# UNITED STATES PATENT AND TRADEMARK OFFICE

Application Number: 10/022,996  
Filing Date: December 17, 2001  
Appellant(s): CALLOL ET AL.

**EXAMINER'S ANSWER**

This is in response to the appeal brief filed Feb. 6, 2006 appealing from the Office action mailed Feb. 15, 2005.

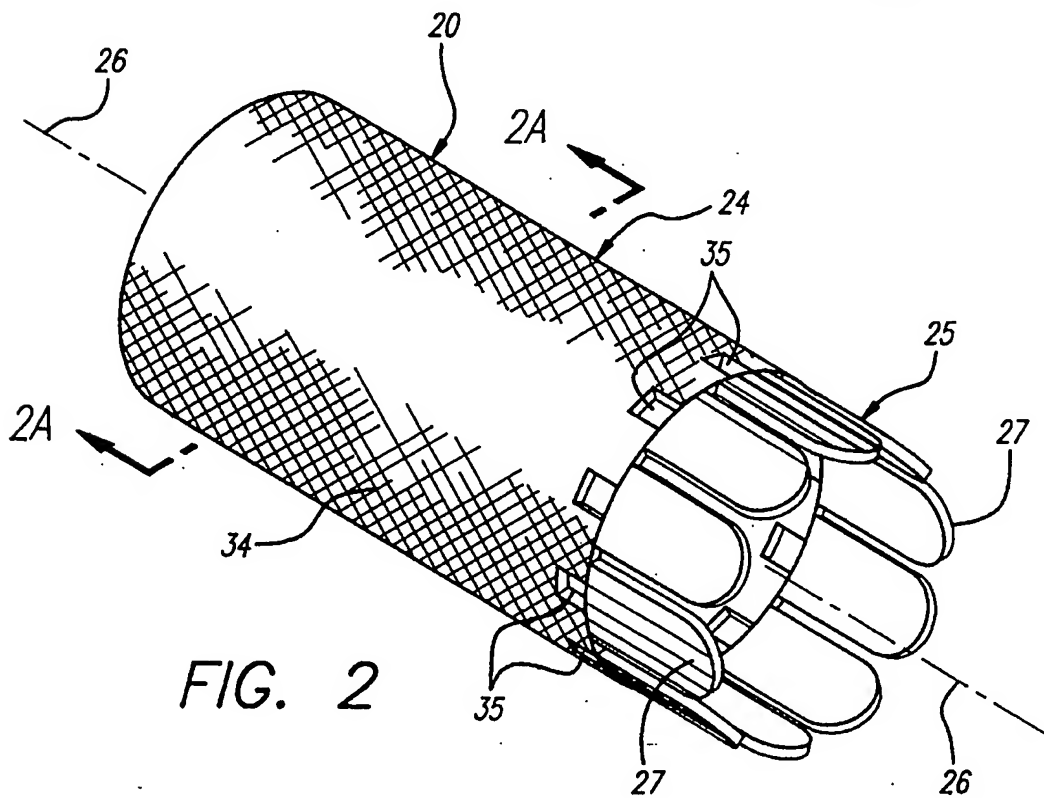
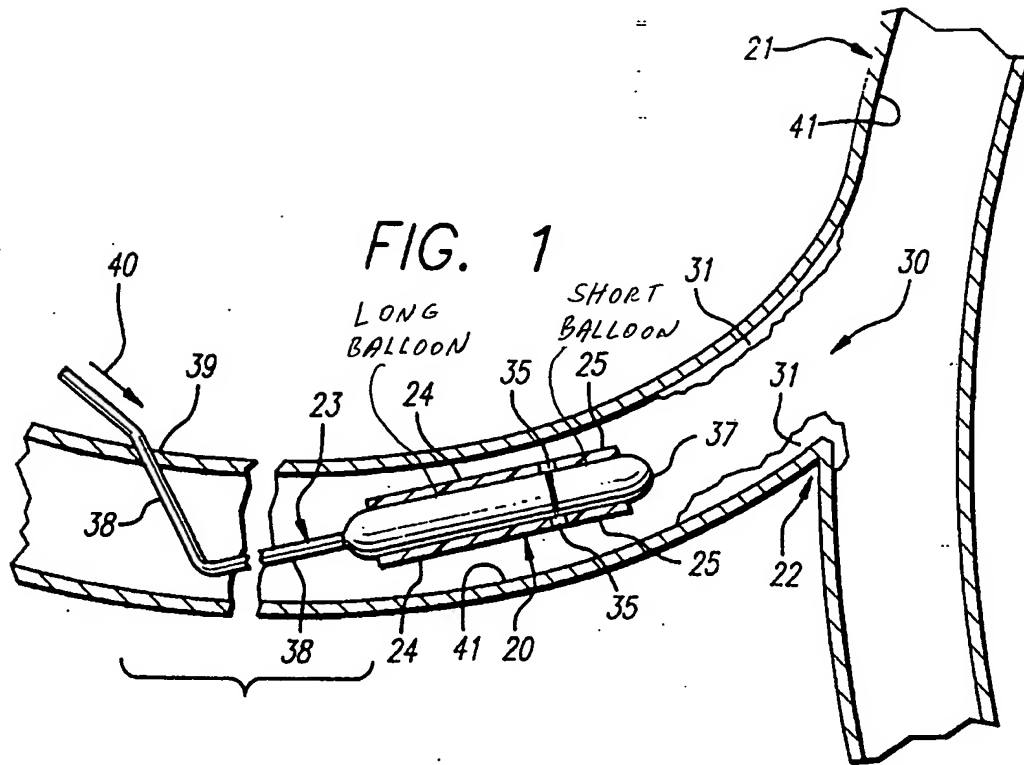
First, the catheter shown in figure 7 has a long balloon on the left side of the figure and a short balloon on the right side of the figure. When the stent is in the process of being mounted on the catheter, the balloons would appear as shown in the attached appendix A, noting that the left balloon is to the left of radiopaque markers 35 (as it is in figure 7) and the

right balloon is to the right of radiopaque markers (as it is in figure 7) and noting that the left balloon is longer than the right balloon. The Lam long balloon and short balloon shown in appendix A are positioned side by side. Dictionary.com defines "side by side" as "next to each other; close together". Appellant's specification does not include an alternative definition for this term. The balloons shown in appendix A are clearly next to each other and close together and are therefore side by side with the left balloon on the left side and the right balloon on the right side.

met by Lam in either of two ways as shown in the attached appendixes A and B. For example, if two rectangular pictures are hanging on a wall near each other with the longest dimension of each picture being the horizontal dimension, and one picture is on left while the other picture is on the right, the pictures are positioned side by side even though the longest dimensions (the longitudinal axes) of the pictures are aligned. Similarly, the balloons shown in appendix A are positioned side by side even though the longest dimensions (the longitudinal axes) of the pictures are aligned. Further, the member of each balloon which faces and contacts the corresponding member of the other balloon each other (best seen in figure 7) may be considered to be a side even though its dimension is smaller than the length of the balloon. The two shorter sides of a rectangle are still considered to be sides even though they are shorter than the other two sides. Further, Dictionary.com defines "side" as "A surface of an object, especially a surface joining a top and bottom: *the four sides of a box.*" Thus, in appendix A, the right side of the left balloon is by the left side of the right balloon.

FIG. 7

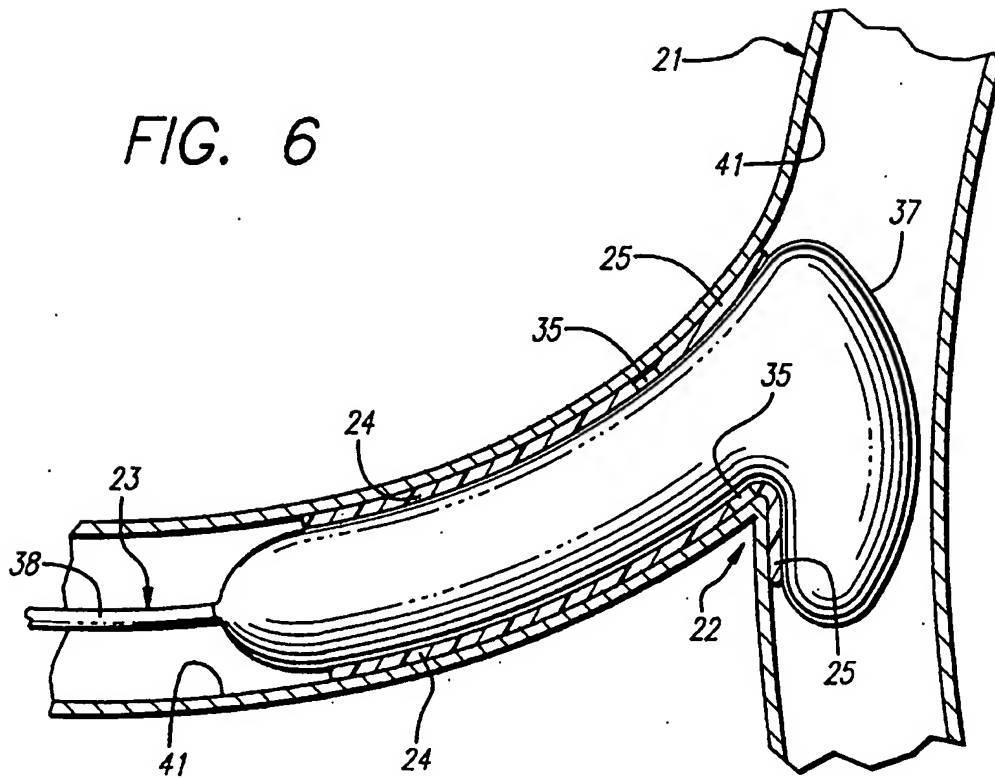
Second, when the balloons are in the expanded configuration shown in figure 7, the balloons are positioned side by side since the side of the lower portion of the short balloon is positioned by the side of the long balloon because the short balloon curves downwardly near the side of the long balloon as shown in the attached appendix B. Although the sides of the balloons are not coextensive for the entire length of the balloons, the term "side by side" does not require this. For example, two pencils which are parallel to each other are side by side even if their sides are not coextensive for the entire length of the pencils. Further, although the balloons shown in figure 7 are not parallel to each other, the term "side by side" does not require this. For example, if two pencils are next to

each other but are not parallel (i.e. they converge towards each other to form a V-shape) they are side by side. Although the balloon configuration shown in figure 7 exists after the step of "mounting the stent on a catheter having a long balloon and a short balloon", the claim does not require the steps to be performed in any sequence. In other words, although the step of "wherein the long balloon and short balloon are positioned side by side" is positioned in the claim immediately following the step of "mounting the stent on a catheter having a long balloon and a short balloon", the claim does not require the steps to be performed in this sequence or any other sequence. In general, unless a method claim specifically indicates the order that the method steps are performed, the claim is broad in the sense that the steps of the prior art can be performed in an order different than the order in which they are listed in the claim and still meet the claim limitations. For example, a claim "A method of making a rod wherein the rod is bent and wherein the rod is heated." would be met by a reference which discloses the heating step being performed before the bending step. The meaning of the term "wherein" in claim 8, line 6 is different than the meaning of "when".

bifurcation 22, positioning the stent so that the second section 25 is aligned with the opening to the side branch vessel (the vessel oriented generally vertically in figure 7), inflating the balloons to radially expand the stent so that the first section 24 is apposes and contacts the main vessel (the vessel oriented generally horizontally in figure 7) proximal of the bifurcation and the second section 25 is apposes and contacts the opening of the side branch vessel and deflating the balloons and withdrawing the catheter. Lam fails to specifically disclose that the first and second sections have a plurality of rings. However, Lam teaches that the stent possesses a tubular structure with some geometric pattern that facilitates shape retention and expansion (col. 5, lines 49-65). Kim teaches that a stent should be constructed of a plurality of rings 14 apparently in order to obtain the advantage of facilitating shape retention and expansion (col. 9, lines 22-33). It would have been obvious to use this construction for the Lam stent so that it would have the above described advantage. As to claim 8, the second section 25 of Lam inherently forms an elliptical cross-section when conforming to the vessel walls 41 (as described in col. 7, lines 8-10) since it expands greatly in the directions to the top and bottom of figure 7 (along the axis of the side branch vessel) but curves around the circumference of

the side branch vessel (in directions out of the plane of the paper of figure 7). Alternatively, assuming arguendo that Lam fails to inherently disclose an elliptical cross section, Kim teaches that the cross-section of a stent should be elliptical when expanded in order to conform to the inner luminal wall (col. 7, lines 16-25 and col. 10, lines 30-33). It would have been obvious to make the cross-section of the Lam stent elliptical when expanded so that it too would have this advantage. As to claims 11-14, Lam fails to disclose the specific rapid exchange catheter. However, it is old and well known in this art to use rapid exchange catheters to facilitate easy exchange of the catheters. It would have been obvious to use such a catheter in the Lam procedure in order to obtain this advantage. The above well known in the art statement is taken to be admitted prior art because applicant failed to traverse the examiner's assertion (M.P.E.P. 2144.03).
